RE: Terra Vi Development - Site Development Permit SDP18-003

The Community Development Department staff has reviewed your August 23, 2023, letter, sent on behalf of your client, Terra Vi, requesting staff confirm the proposed changes to the Project are in substantial compliance with the original Project approvals, incorporate these changes into the Project approval, and enter these limitations into the County's permit tracking software. The revised site plan, dated August 20, 2023, reflects the following:

RE: Substantial Cultural Resources, Terra Vi UPDATED

RE: Substantial Compliance Biological Resources, Terra Vi

Attachment A

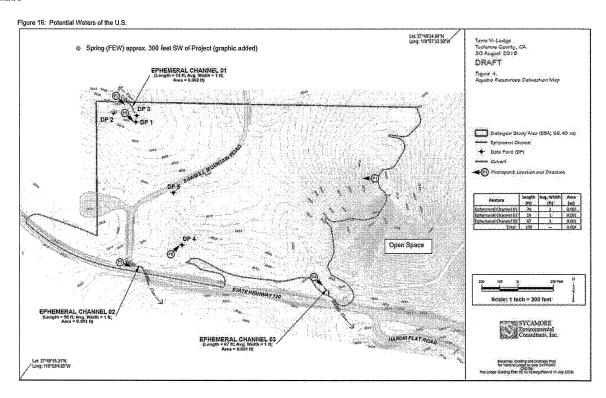
For the purposes of this study, the Biological Study Area (BSA) is that area surveyed for biological resources and evaluated for potential direct and/or indirect and cumulative impacts to common and special status species and their habitats. It is illustrated in **Figure 4** and detailed as follows:

- <u>Staging areas</u>: All staging areas were assumed to be within the parcel boundaries and outside of the existing 21-acre Open Space zoned area. Staging areas were surveyed intensively.

- <u>Plants</u>: All areas within the project boundaries were surveyed intensively for special status plant species except for areas within the existing Open Space zoning district where development is not proposed.

- <u>Amphibians/Special Study Area</u>: The drainage¹ located on USFS property west of the parcel boundaries was surveyed on foot for special status amphibians and special status plants given its proximity to the site and potential to support special status species.

Attachment B

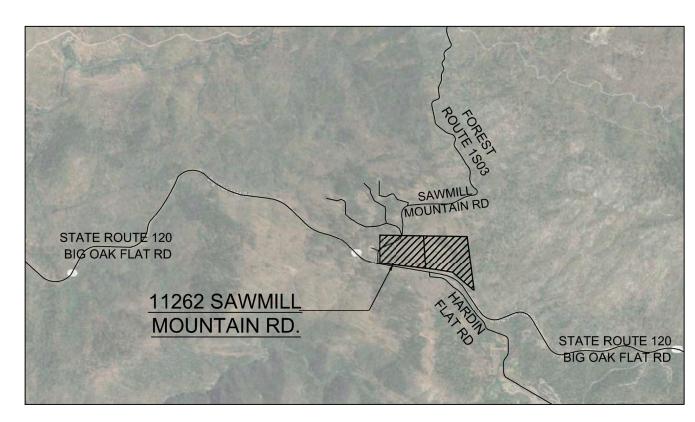
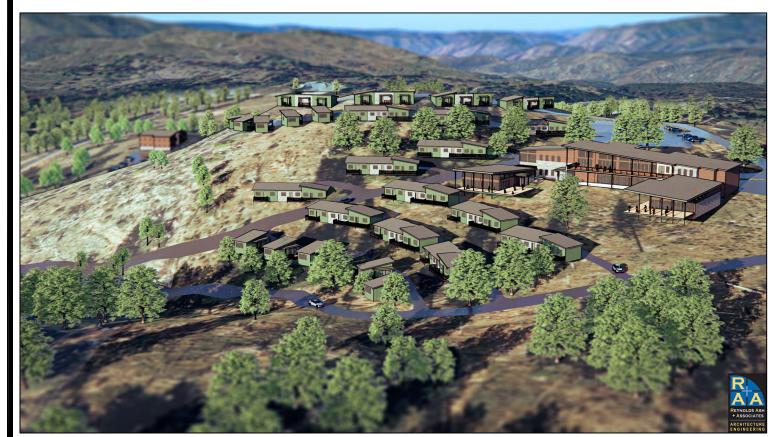
Our work with respect to the Biological Resources section of the EIR is incorporated in the Draft and Final Environmental Impact Report ("EIR") (State Clearinghouse Number 2019110286) for the Terra Vi Project and detailed in *Terra Vi Lodge, Yosemite, Biological Study Report* (APA, June 2020). Our prior review included all of the property with intensive studies conducted in accordance with the attached maps (Attachments A and B).
